R224 – 2024

Certificate of Appropriateness for work in the Historic Districts:

**Historical Architectural Review Board
COA Preliminary Review Sheet**

HDC-2024-00104

Front Elevation (Applicant)

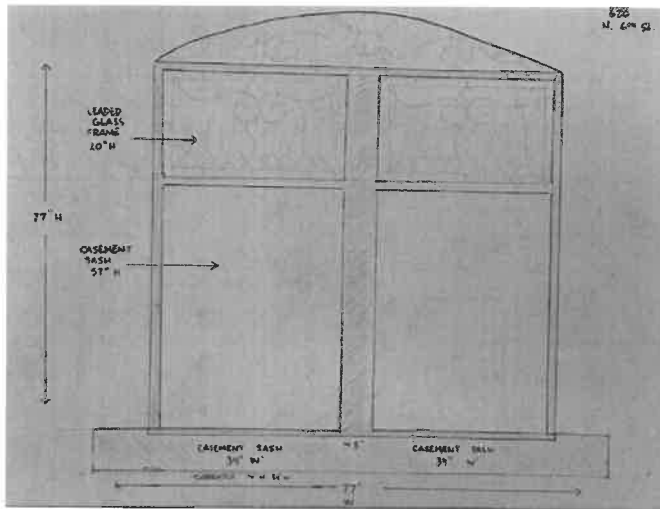
Observations & Comments: The existing first floor windows at 620 N. 6th Street are replacement windows that altered the configuration of the original historic windows; 1991 and 1998 photographs show the historic configuration. The salvaged windows proposed for installation follow that original configuration, materiality, and style. The proposed windows are appropriate, as they restore the historic character of the façade.

Staff Recommendation: Staff recommend approval, and either transom style is appropriate.

1991 Front Elevation (City of Allentown)

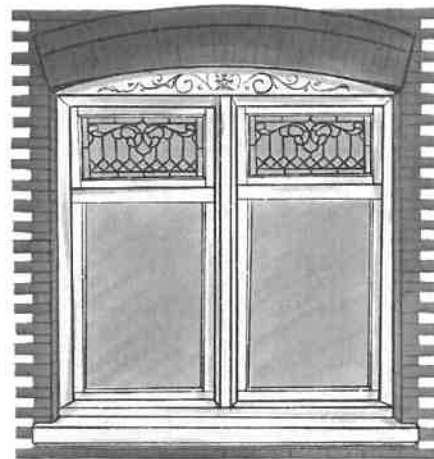
The application includes two styles of salvaged decorative transoms; it is unclear if the applicant is seeking recommendation. Either style would be appropriate, and staff preference would be for the white-framed diamond pattern without scrollwork, as it most closely resembles the wood muntin pattern of the attic dormer window.
